Project Number: SP2019-045
Project Name: Channel Corp
Project Type: SITE PLAN
Applicant Name: Pross Design Group
Owner Name: Channell Commercial Corp.
Project Description: Discuss and consider a request by Mark W. Pross of Pross Design Group, Inc. on behalf of Alton Frazier of Channell Commercial Corporation for the approval of an amended site plan for an existing industrial building on an 18.762-acre parcel of land identified as Lot 2, Block A, Channell Subdivision Addition, City of Rockwall, Rockwall County, Texas, zoned Light Industrial (LI) District, situated within the SH-205 By-Pass Overlay (SH-205 BY OV) District, addressed as 1700 John King Boulevard, and take any action necessary.

Project Number SP2019-045	Owner Channell Commercial Corp.	Applied 11/18/2019	DG
Project Name Channell Corporation	Applicant Pross Design Group	Approved	
Type SITE PLAN		Closed	
Subtype AMENDING		Expired	
Status P&Z HEARING		Status 11/22/2019	DG

TO: Planning and Zoning Commission
FROM: David Gonzales, *Planning and Zoning Manager*
DATE: December 10, 2019
SUBJECT: SP2019-045; *Amended Site Plan for an Existing Manufacturing Facility (Channell Commercial Corporation)*

1 SITE PLAN
SCALE: 1"=60'-0"

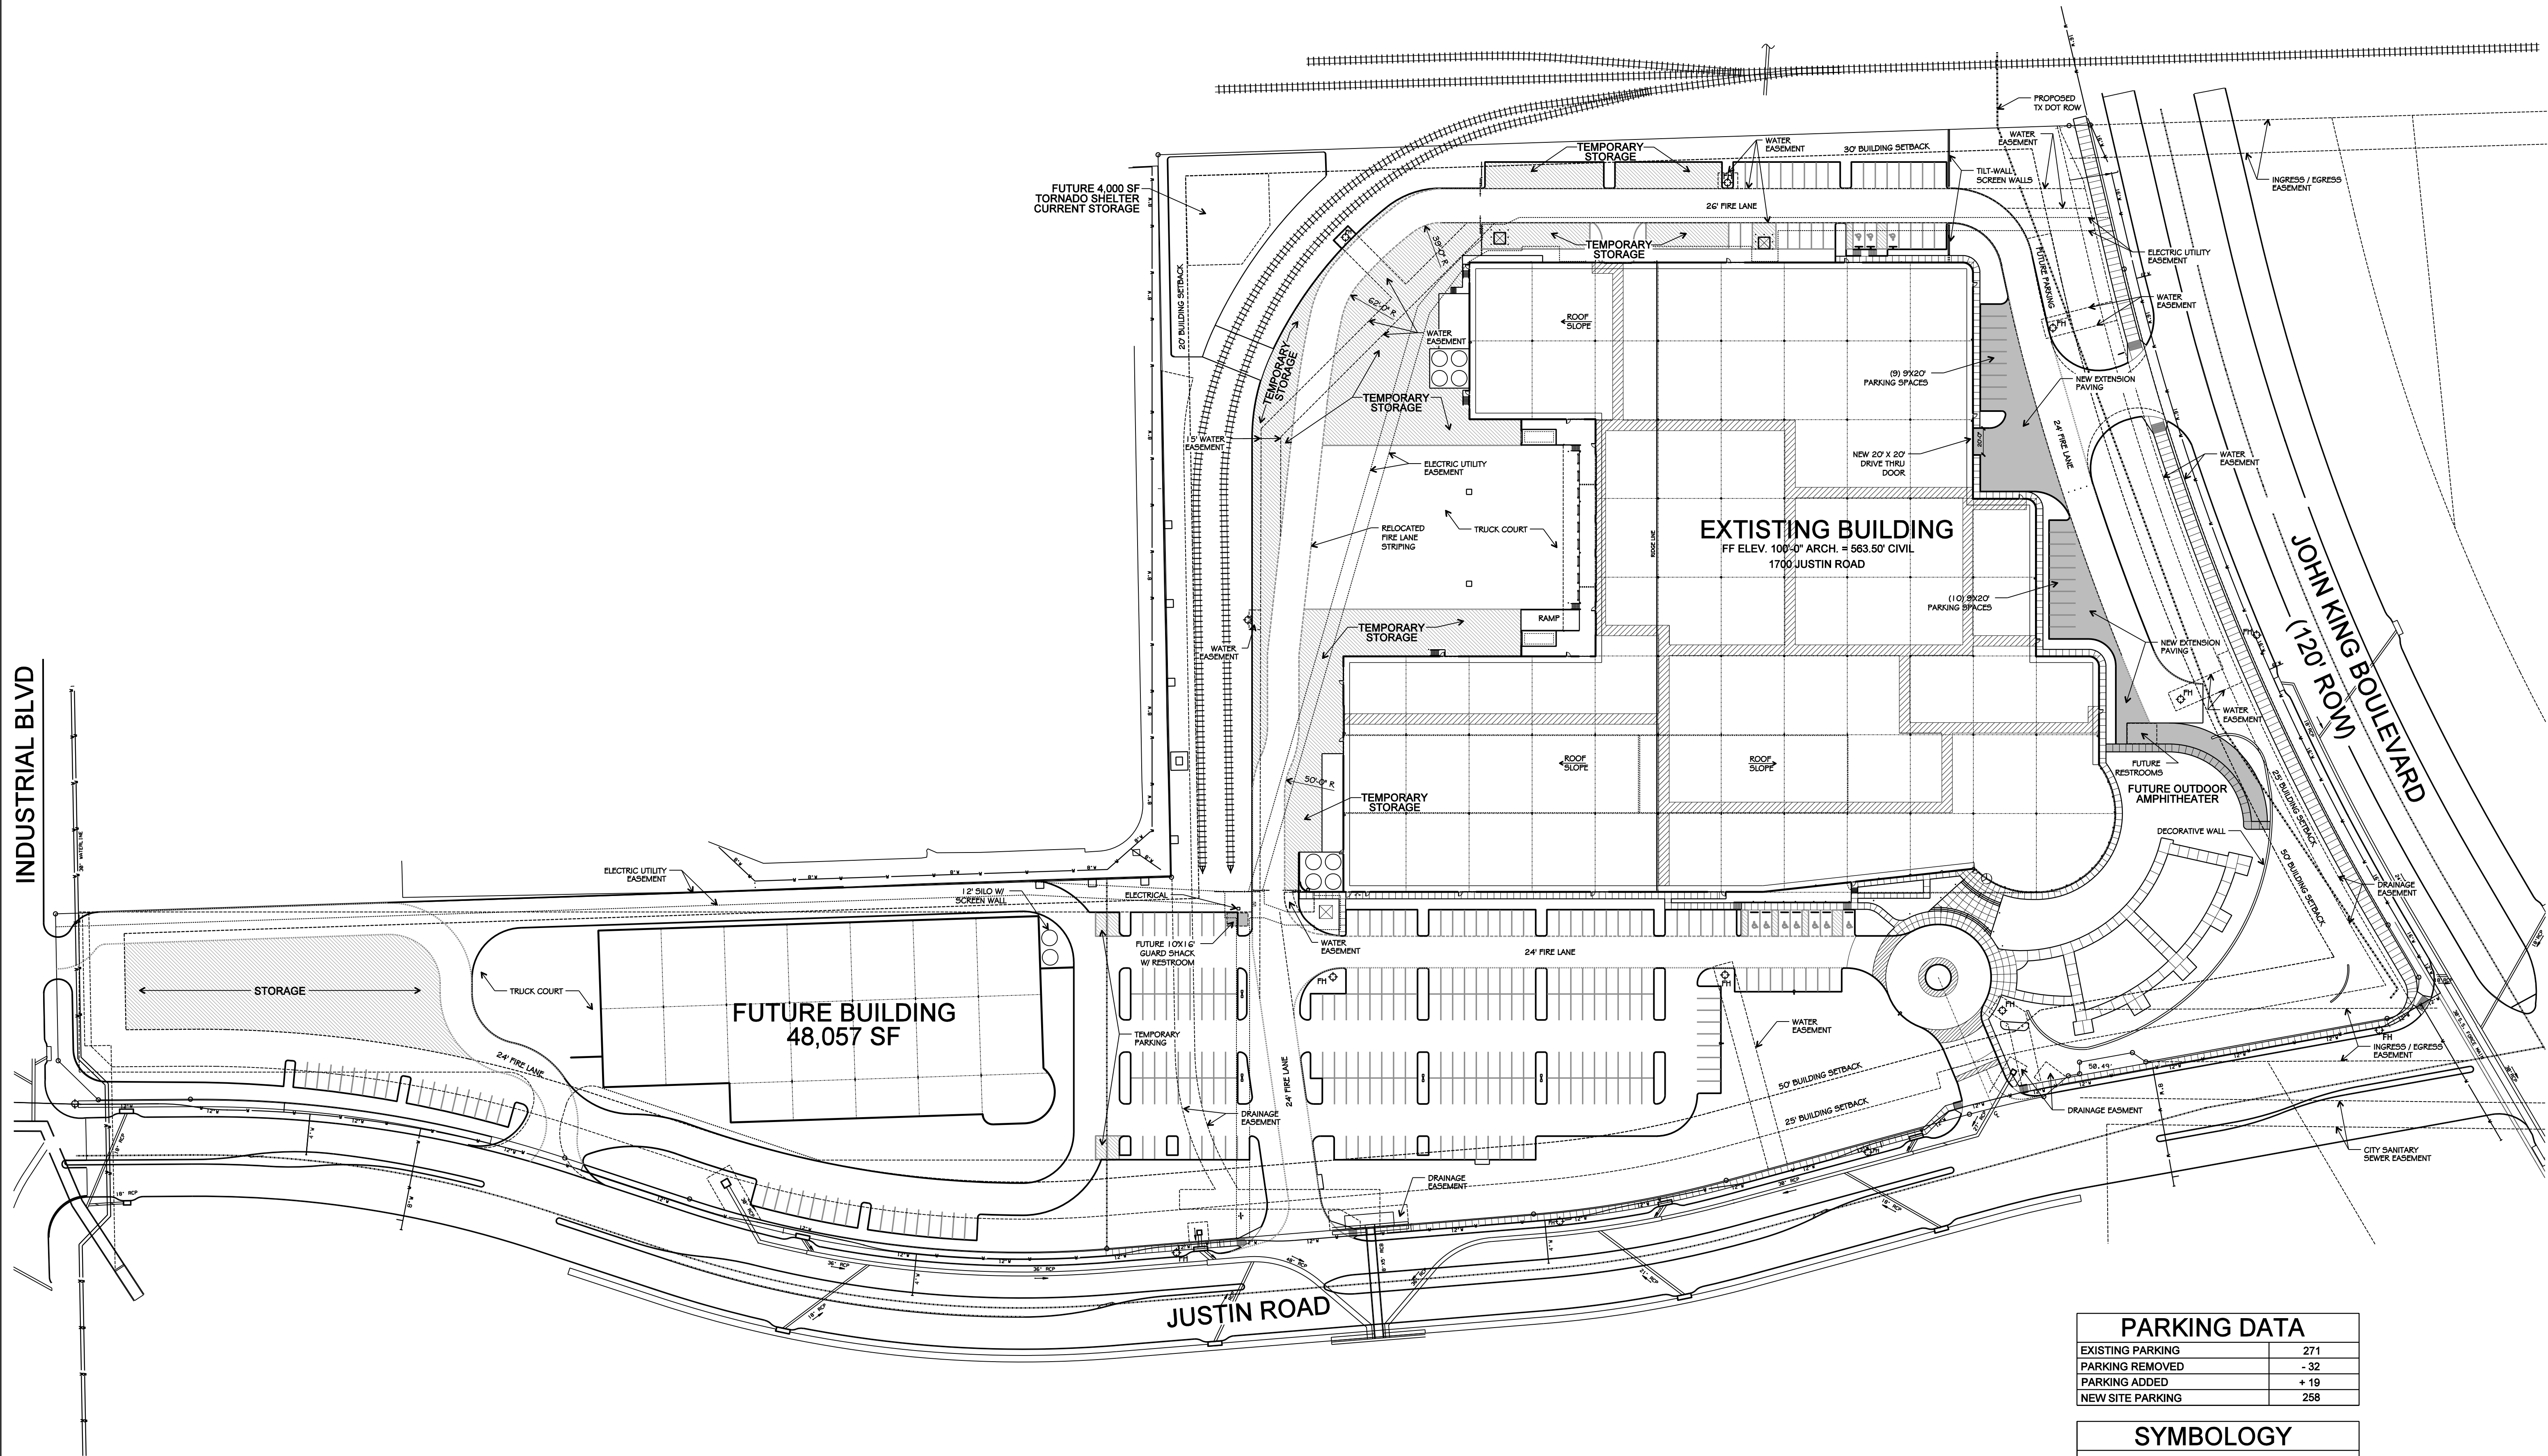
1) Under the Parking Data table, the removal and addition of parking spaces are resulting in a net loss of 13 parking spaces. This will require approval of a variance to allow for the parking to not meet the standards. Additionally, with future parking being indicated on the east portion of the site, it is encouraged to provide staff with the total parking for this site (i.e. include, but hatch the future parking spaces) for an overall parking layout. Please provide the parking count for each use (i.e. office, warehouse, & manufacturing) and include the number of employees on each shift as justification-- refer to the approved 2014 site plan SP2014-011 as an example. (Section 6, Table 3, of Article VI, of the UDC) Exception Required (Section 9, Art. XI, UDC).

2) Provide a label identifying the parking count (i.e. 9, 10, etc.) for each parking aisle in order to verify the existing and proposed parking spaces

3) Provide total SF of additions (i.e. parking areas, building additions, etc.).						
4) Hatch the area located on the eastern portion of the lot (noted as future building) to better delineate the existing area vs future building area(s).

5) Outside storage areas are to be screened to the height of what is being stored (Subsection 1.05(5), of Article V, UDC). Is the proposed storage area on the eastern portion of the lot (i.e. future area) being considered? If so, see Subsection 5.02.A, of Article VIII, of the UDC for appropriate screening of this area

6) Provide a label identifying the existing and proposed sidewalks, including the existing 10-ft trail/walkway along John King Blvd.						
7) Provide a standard signature block with signature space for the Planning and Zoning Chairman and Planning Director. See attachment with packet provided

8) There is a label on the North West corner of the site indicating future parking. Is there going to be future parking along this area as indicated?						
M.7 Building Elevations. Provide building elevations for the proposed guard shack (Section 3, of Article XI, of the UDC).						
M.8 Landscape Plan. The proposed landscape screening located at the North West corner of the site requires approval by the Planning and Zoning Commission to allow for not meeting the standards of Subsection 1.05, Screening Standards, of Article V, District Development Standards, of the UDC (Subsection 5.02(C), Art. VIII, UDC).						
I.9 Civil Set. As a note, the civil set submitted with this application on CD were not reviewed and are not considered an engineering submittal with this application

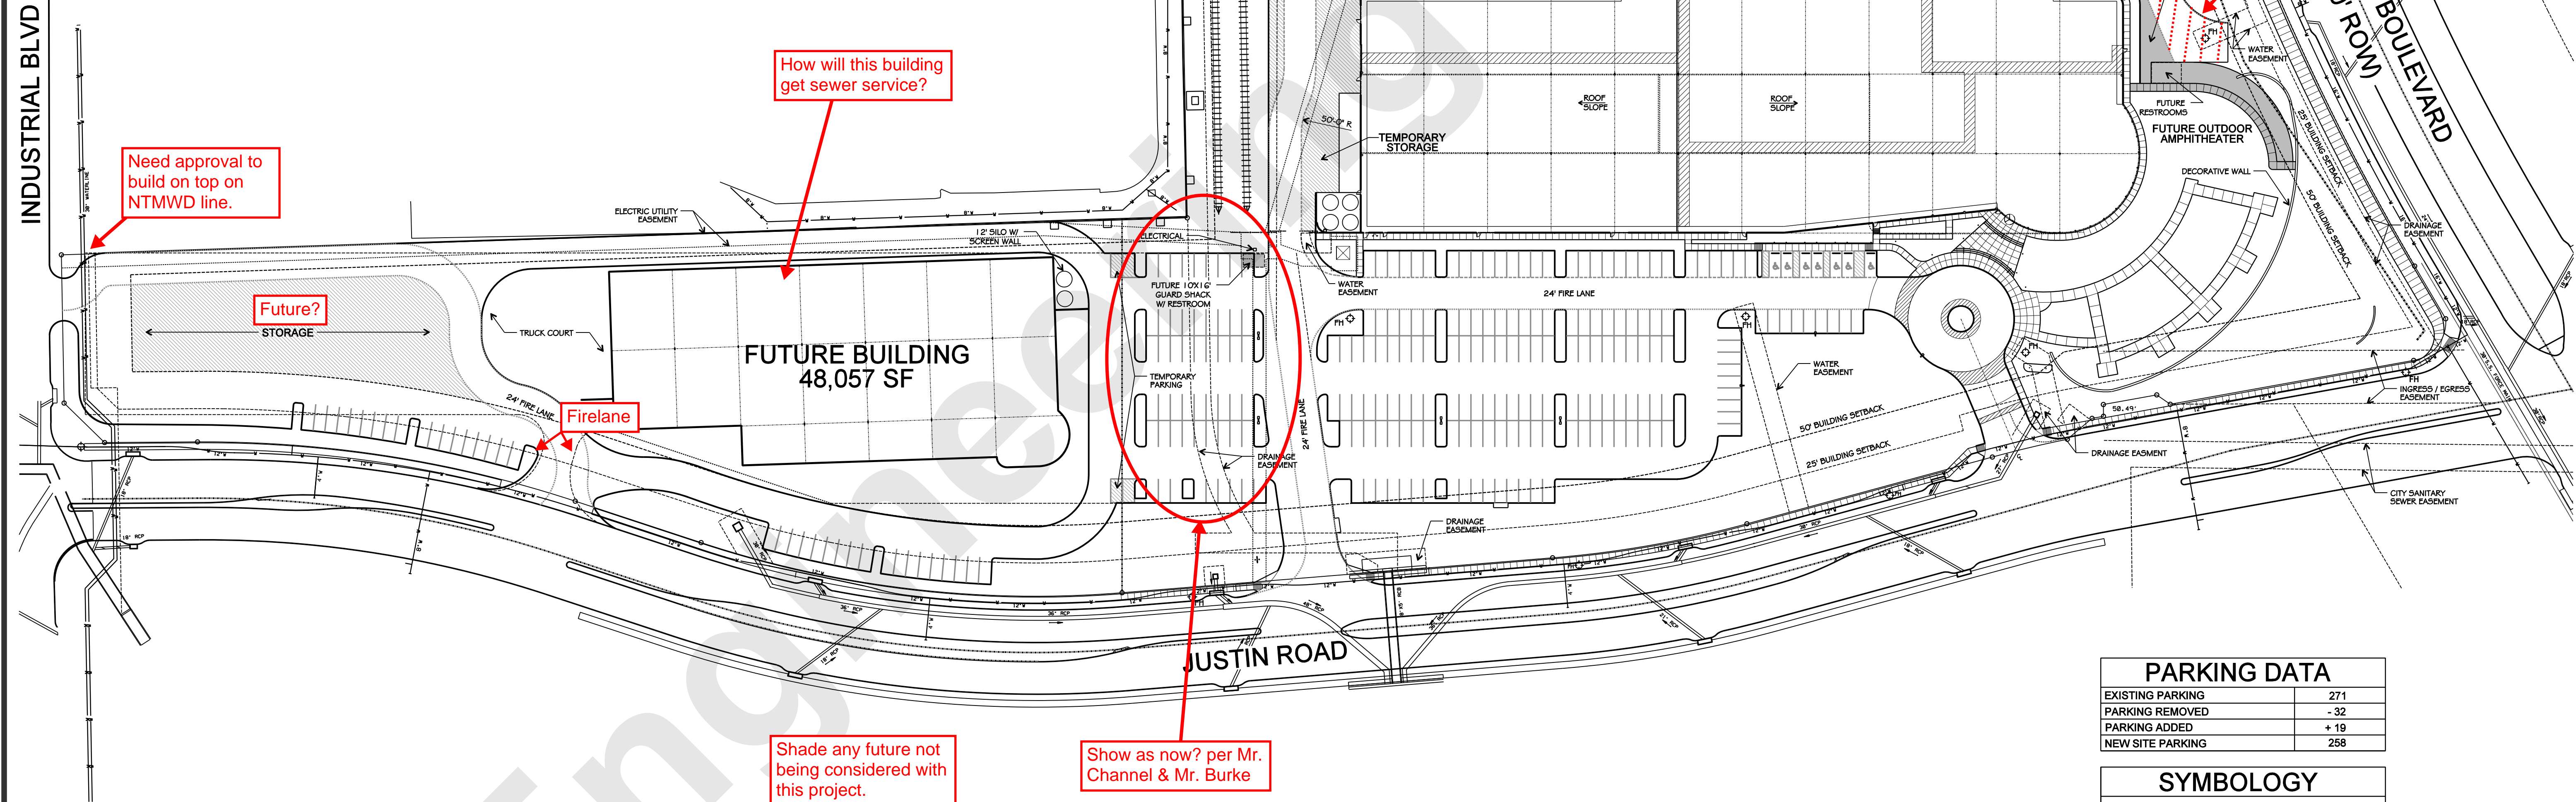
Need approval to build on top on NTMWD line.

Future?

How will this building get sewer service?

Shade any future not being considered with this project.

Show as now? per Mr. Channel & Mr. Burke

Isn't this whole section new. not there today. will need to relocate fire hydrant need to check spacing.

DRAWING TITLE
LANDSCAPE PLAN - ADDITION

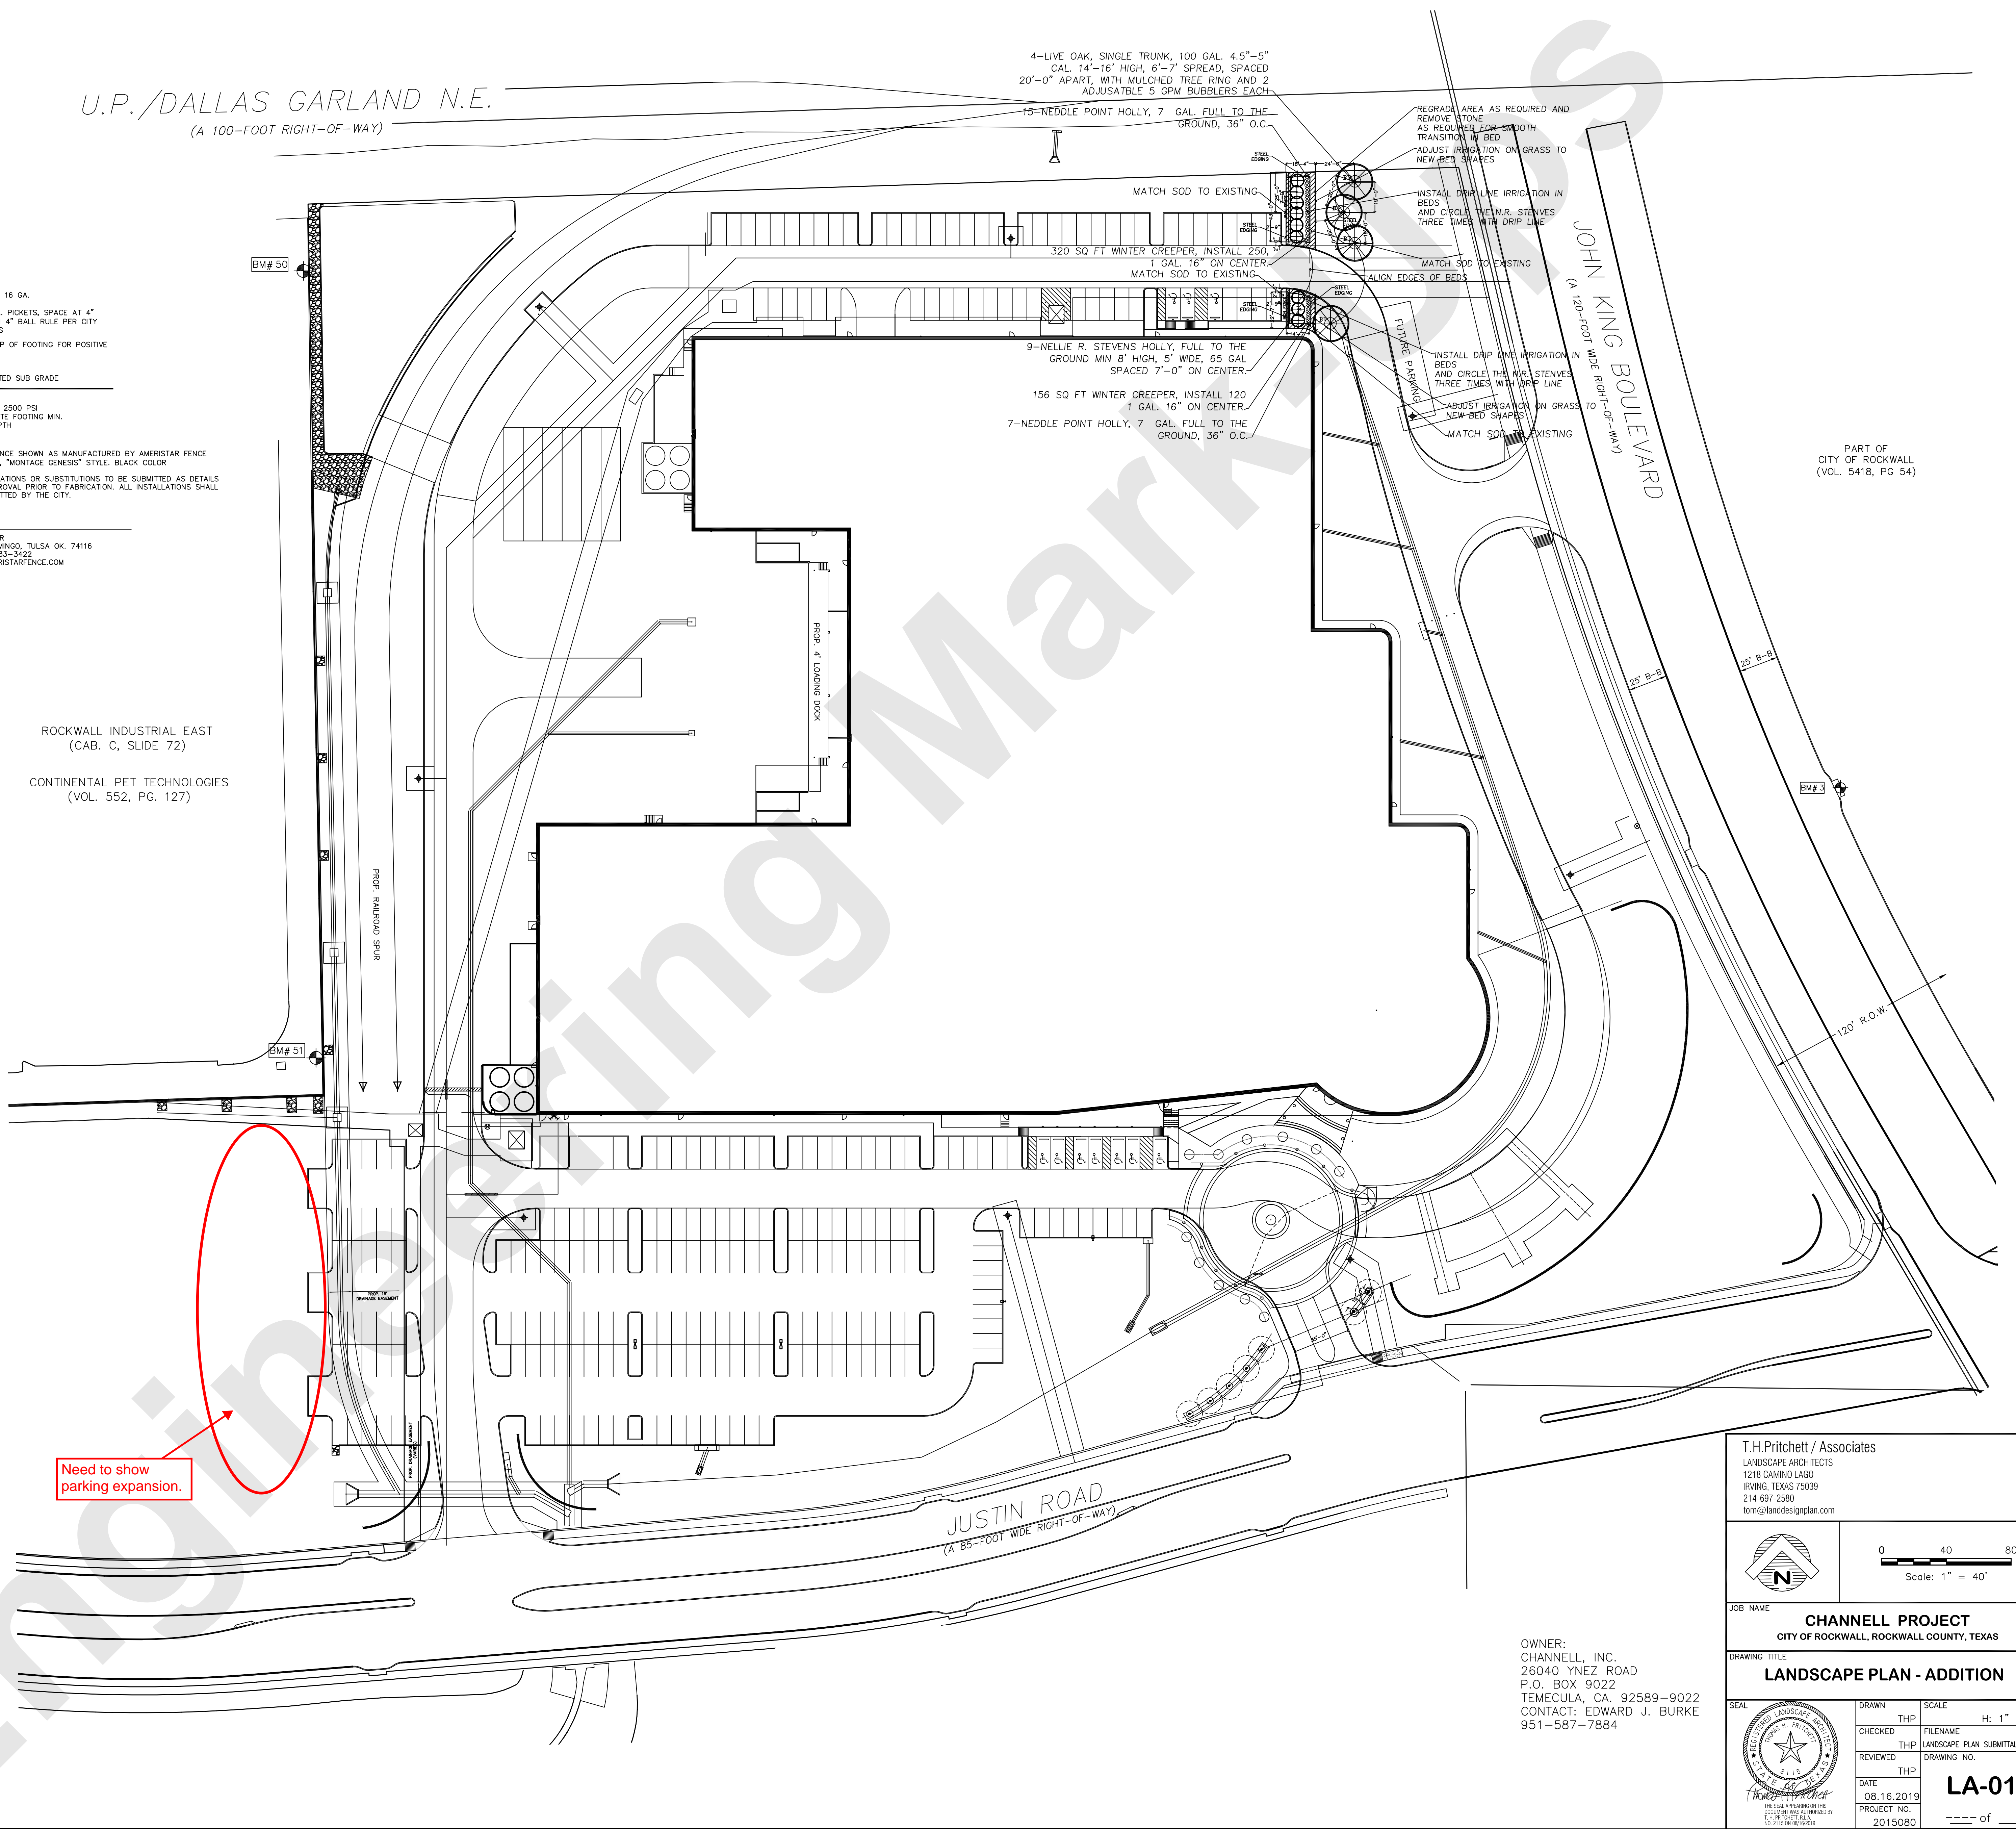
Add note:
No trees within 5' of public utilities.

Need to show parking expansion.
